Memorandum  
City of Lawrence  
Planning and Development Services

**RE:** Minor Subdivision, MS-15-00342, variance request to reduce the right-of-way radii for an existing cul-de-sac and to allow subdivision to exclude construction of public sidewalks along W. 19<sup>th</sup> Terrace per Section 20-813(g) of the Land Development Code for University Field Subdivision No. 6, located at 1745 W. 19<sup>th</sup> Terrace. Submitted by Matthew and Jessica Douglas for Mountain Top LLC, owners of record.

# UNIVERSITY FIELD SUBDIVISION NO. 6

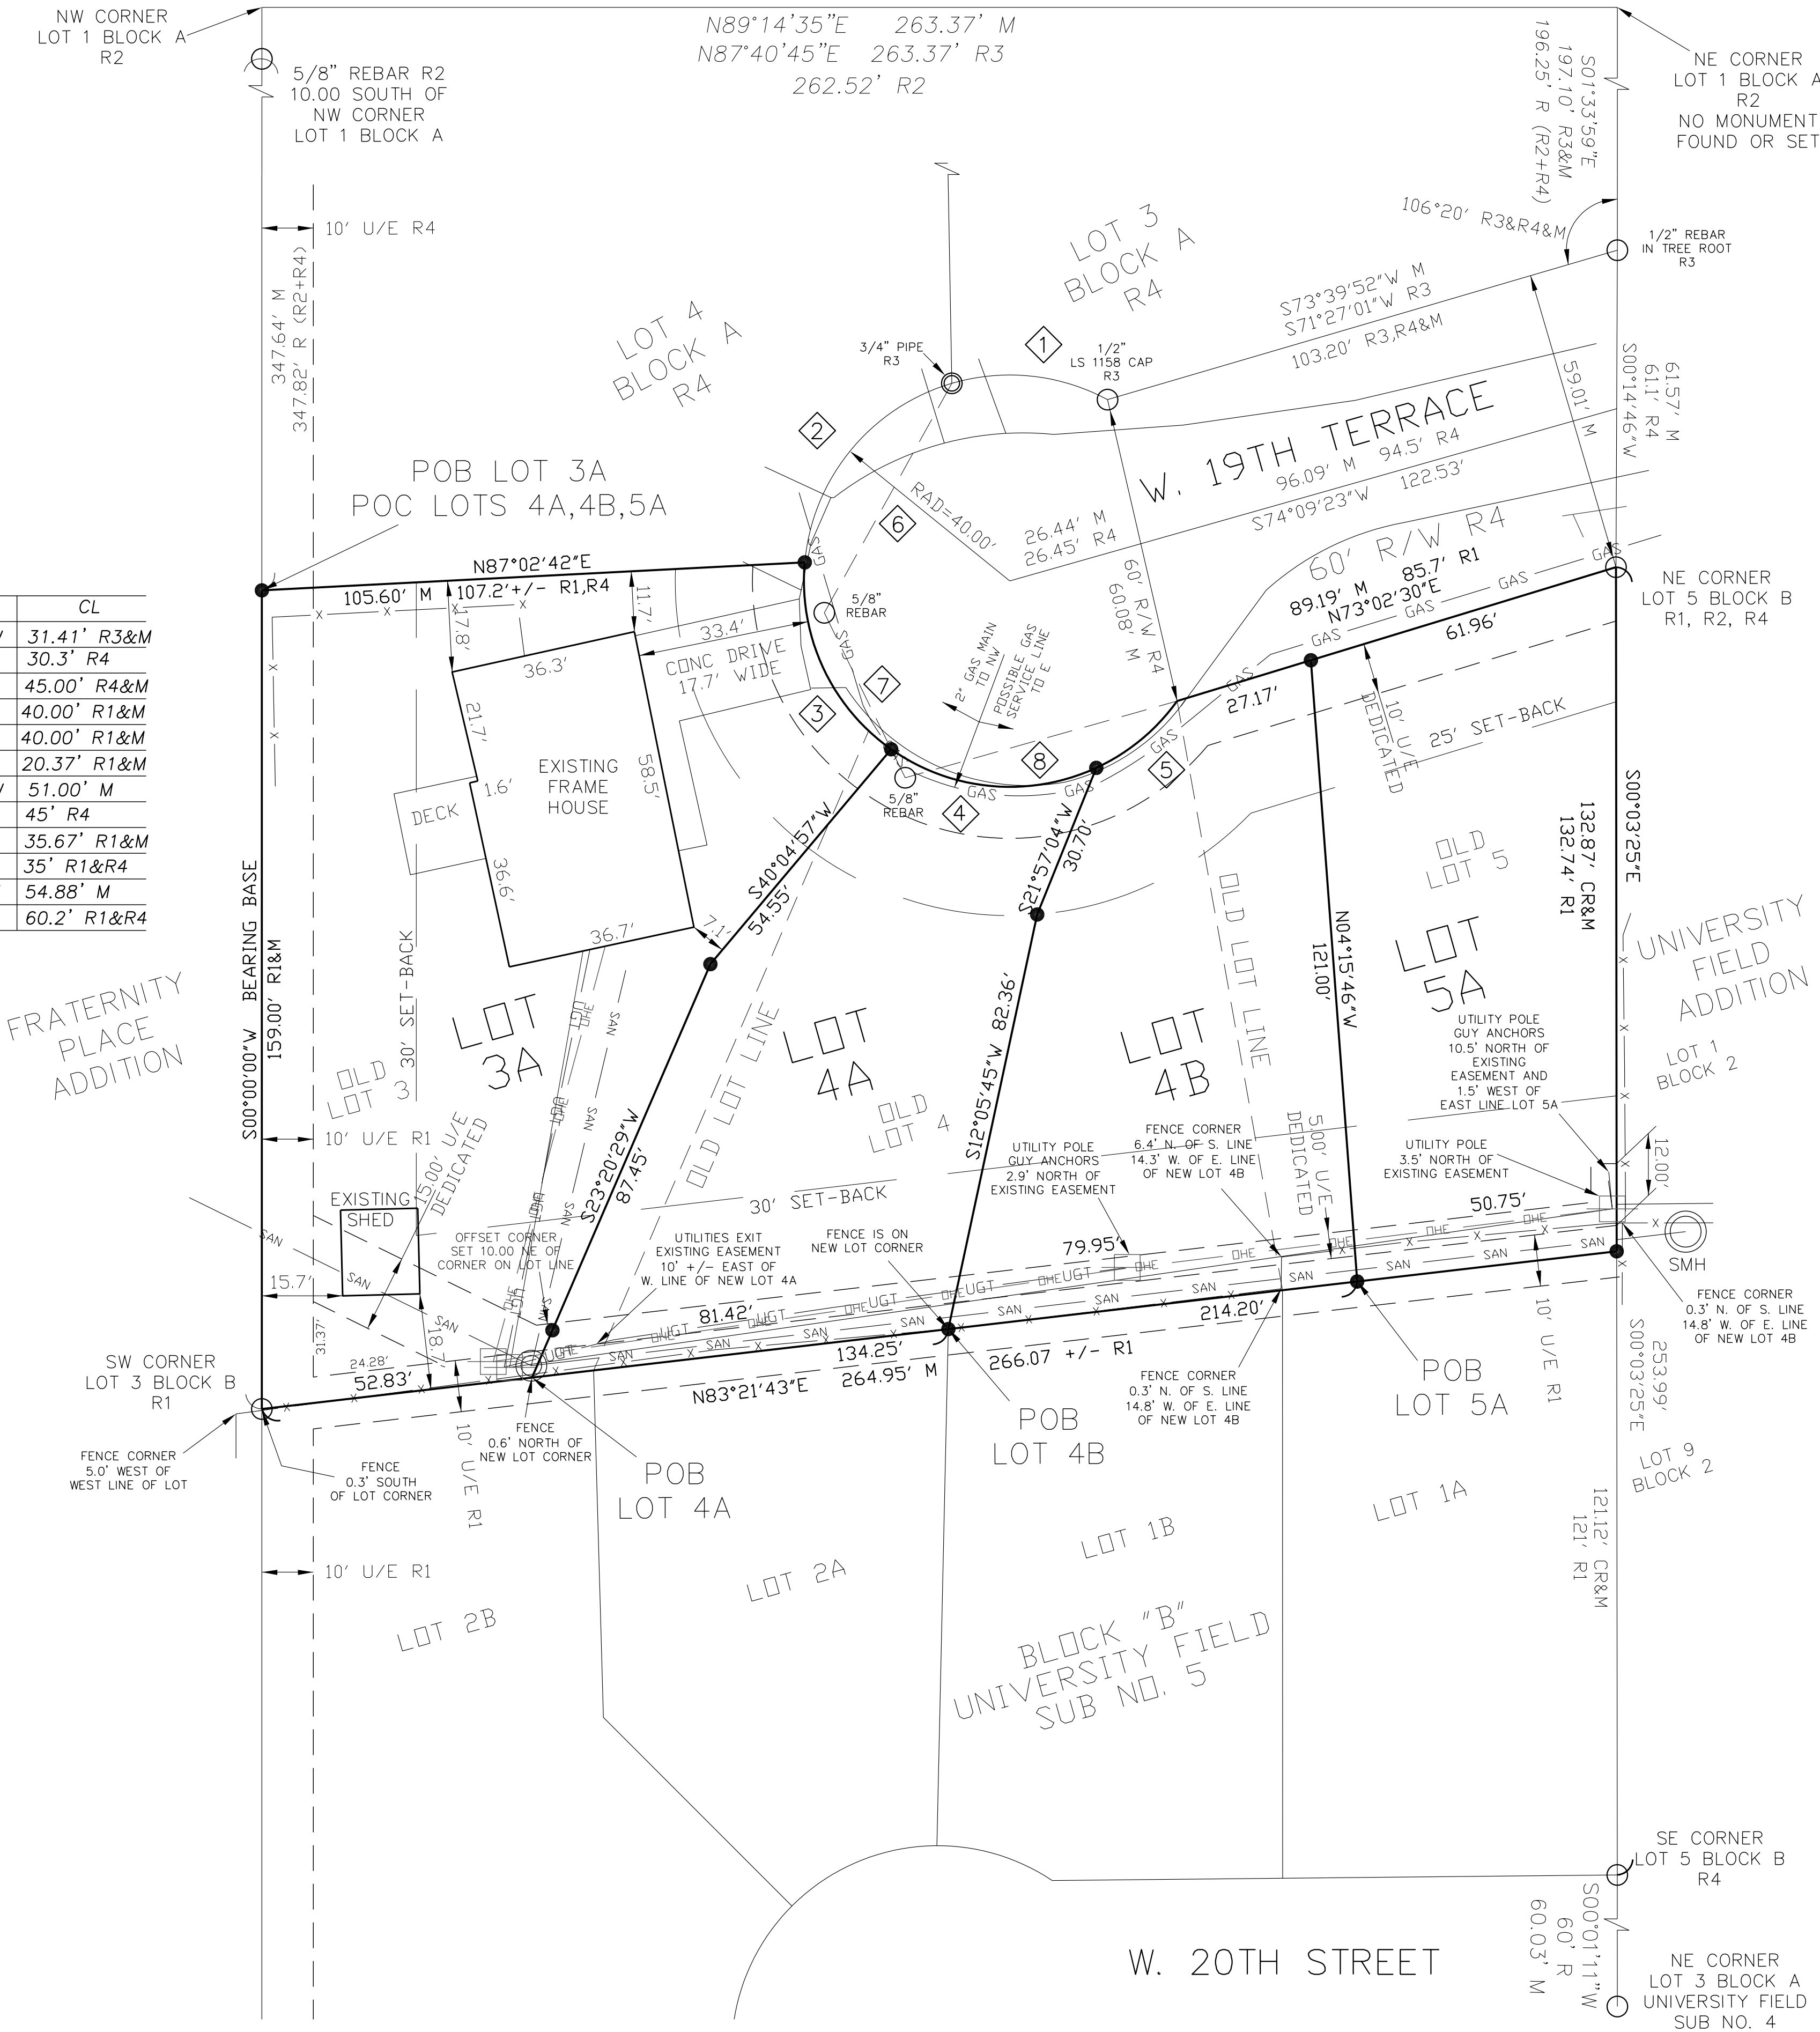
**VARIANCE #1:** Reduction in the width of the right-of-way bulb from 60' to 40' as required for a cul-de-sac per Section 20-810(e)(5). The current design standard for a cul-de-sac bulb is 60'. This area is developed with a smaller cul-de-sac bulb that terminates W. 19<sup>th</sup> Terrace.

**VARIANCE #2:** The proposed Minor Subdivision includes the creation of 4 new residential lots where there are currently only 3 lots. Per Section 20-811(c) public sidewalks are required. Local streets require the construction of a minimum 5' wide sidewalk. This request seeks to exclude construction of a new sidewalk along this existing street segment as there are no sidewalks along the remainder of W. 19<sup>th</sup> Terrace.

**STAFF FINDING:** Strict application of the regulations would require acquiring additional right-of-way that is out of the applicant's control. Reconstruction of the street to current design standards would result in creating non-conforming building setbacks for the two existing residential structures that take access from W. 19<sup>th</sup> Terrace.

Requirement to construct the sidewalk would result in a partial sidewalk segment along only one side of the street with no reasonable expectation that it will be extended to the east to connect with the Ousdahl Road sidewalk.

**STAFF FINDING:** Granting this requested variance from the required right-of-way and exempting the construction of a sidewalk is not opposed to the purpose and intent of the regulations.

**STAFF FINDING:** Granting this requested variances from the required right-of-way and construction of a sidewalk will not harm the public health, safety or welfare.

Approve the variance requested for a Minor Subdivision, MS-15-00342, to reduce the right-of-way from Section 20-810(a)(5) for a cul-de-sac bulb from 60' to 40' and to allow the exemption for the construction of a new sidewalk per Section 20-813(g) of the Land Development Code for property located at 1745 W 19<sup>th</sup> Terrace.
